Re: One Post Office Square, Boston - Article 37 Green Building Comment Letter

Re: **One Post Office Square Office Tower and Garage Improvement Project**

***Re: One Post Office Square Office Tower and Garage Improvement Project –
The Langham Hotel’s Comments on the Expanded Project Notification Form***

To: Arthur Kreiger, David Lyons, Anderson & Kreiger LLP (A&K)
From: Jennifer Lenz, P.E., Bruce Fairless, P.E. GZA GeoEnvironmental, Inc.
Date: March 6, 2018
File No.: 01.0173624.00
Re: **Abutter Protection during Demolition/Construction** – Langham Hotel, Boston

Exhibit A

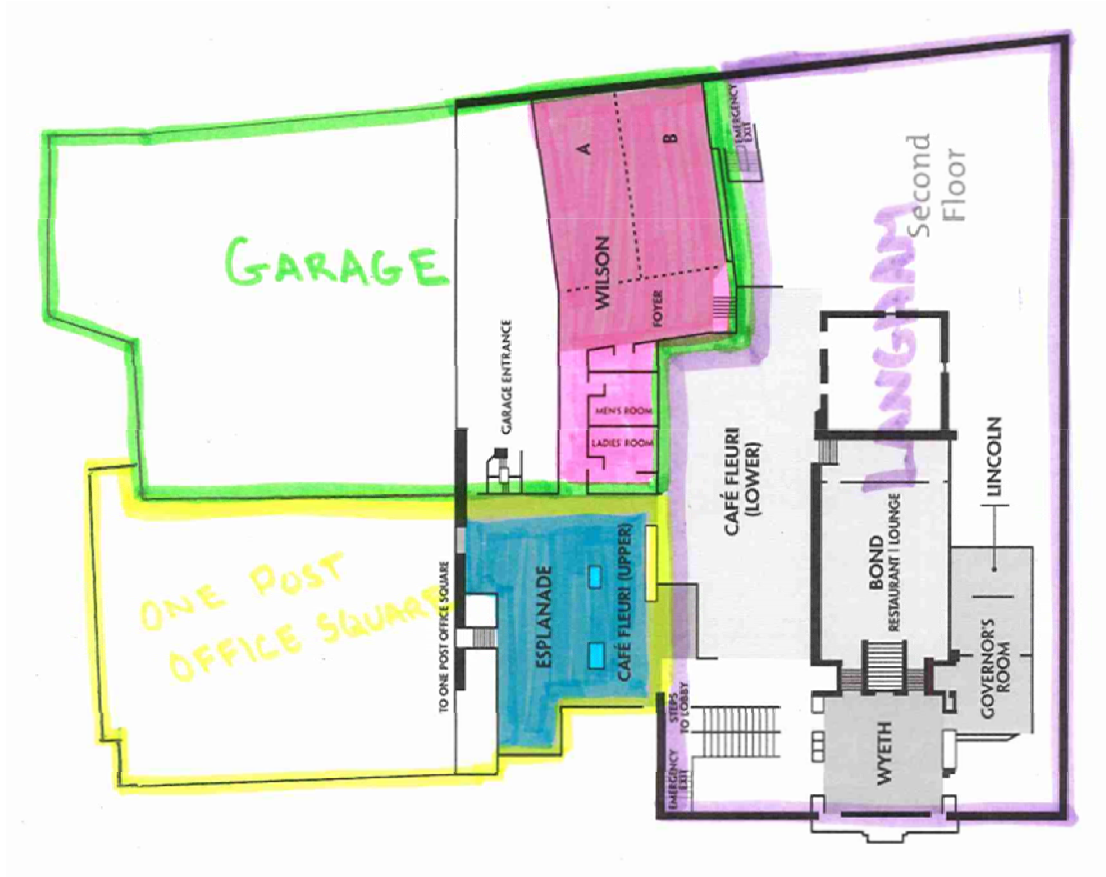
The Langham not only abuts One Post Office Square, the buildings are structurally and operationally connected, sharing a loading ramp on Oliver Street and underground loading facilities. As described below, they also share space and facilities under several easements and long-term leases granted or entered into by the Applicant’s predecessors. Those easements and leases involve areas of critical importance to the hotel that would be demolished or rendered unusable by the Project. The locations of the Langham, the Tower and the Garage are depicted on Exhibit A.

- Finally, the Langham has a lease for the “Esplanade,” located in the Tower two floors above the Breezeway. The Esplanade is a set of function spaces that serves as preparatory and accessory space for events in the ballroom and provides additional seating for the Café Fleuri. *See* Exhibit A. This lease also runs through 2046.

Procedural failure aside, the Project would trample on the Langham's rights. The EPNF depicts new retail space in the drop-off/pick-up lane between the Breezeway and the hotel doors. The Langham undisputedly holds the entire fee interest in that area, as shown by the survey submitted by the Applicant with the EPNF. *See Exhibit B, attached (the drop-off/pick-up area is highlighted on the hard copy).* Simply put – and rather remarkably – the Applicant has proposed to build part of the Project *on property the Langham owns* without even discussing that proposed encroachment with the hotel.
